15-21 WILLIS STREET WOLLI CREEK - DEVELOPMENT APPLICATION DA-2015/279

**CLAUSE 4.6 VARIATION (AMENDED) – FLOOR SPACE RATIO (DA2015/0279)
15-21 WILLIS STREET, WOLLI CREEK**

Figure 4: Original plan

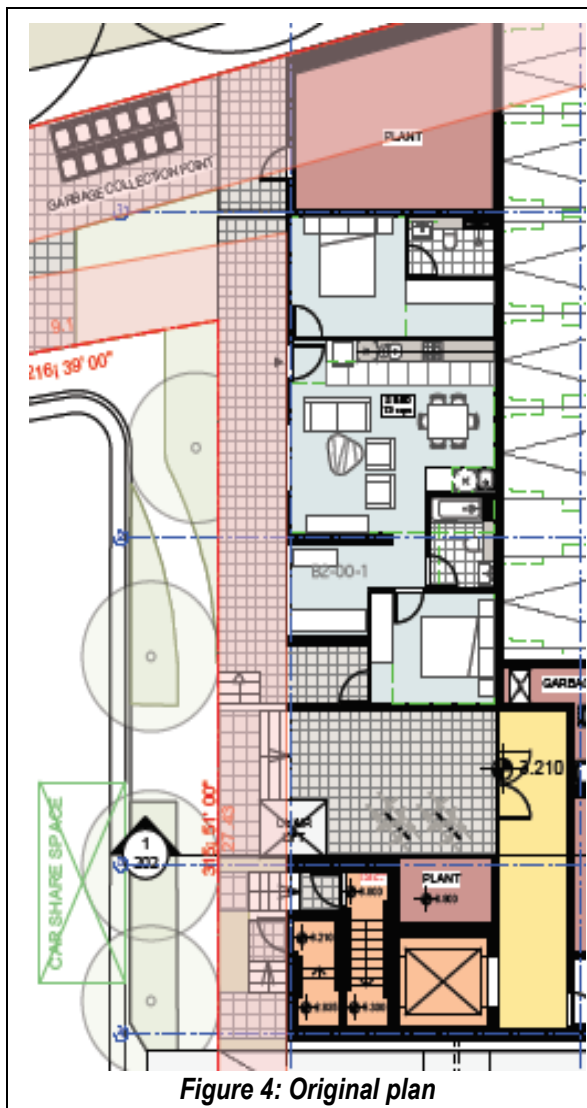
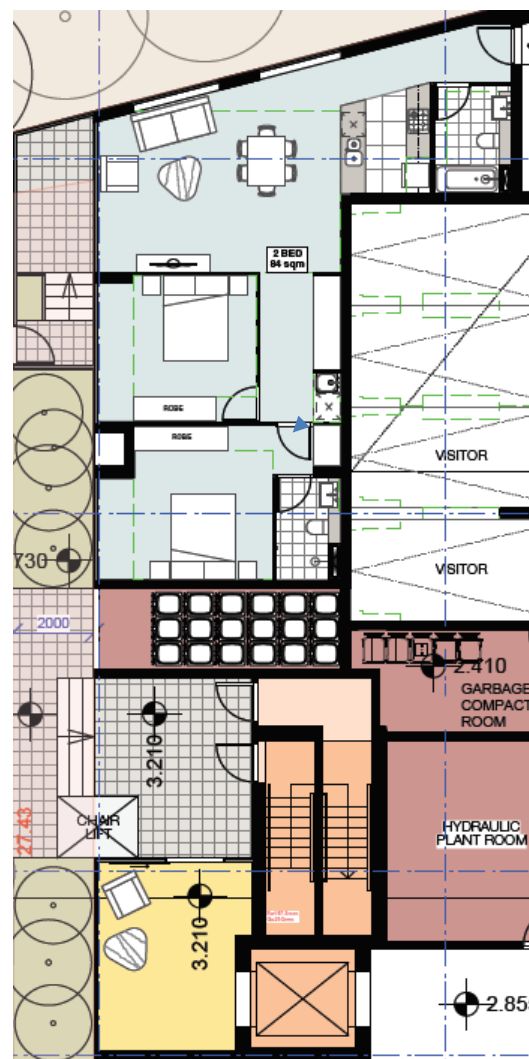
In relation to the ground floor 2 bedroom apartment on Willis Street, the Design Review Panel was of the view that it had an uncomfortable relationship to the street and poor entry, with two door swings in conflict. To access the lift and basement, the resident would need to leave the building and re-enter the main entry which is inconvenient and potentially insecure. In addition, the panel said that the main entries to each block need to be increased in size by moving the doors outwards towards the face of the building.

The amended design provides a better relationship to the street with the ground floor apartment now sleeved by landscaping. The lobby also presents better to the street and has a more functional sitting area. The garbage holding room is also now internalised as requested without being visually dominant in the street facade. Again, all of these changes resulted in an incremental increase in GFA.

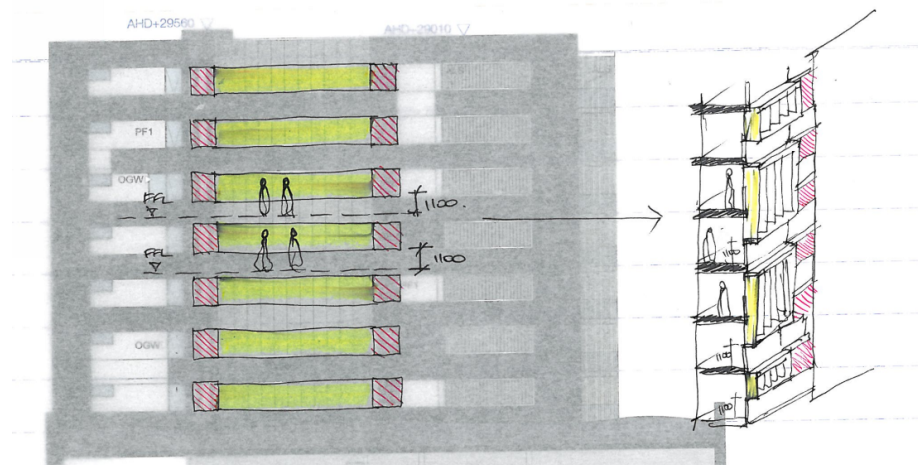
- 15 In our view, the fixed open louvres (as depicted in drawing SK100) would not provide meaningful protection against heat, rain or harsh weather. They would provide no substantive protection against noise or odours. The louvres themselves would not be an adequate safety barrier sufficient to prevent people and objects from falling.

- 25 Accordingly, in our opinion, the position would not change if the open corridors remained the same, but the fixed open louvres were removed and a solid balustrade was instead used for each open corridor. That is, we consider that (as we said for issue 1) the open corridors depicted in drawing SK100 must still be excluded from the calculation of 'gross floor area' under the LEP.
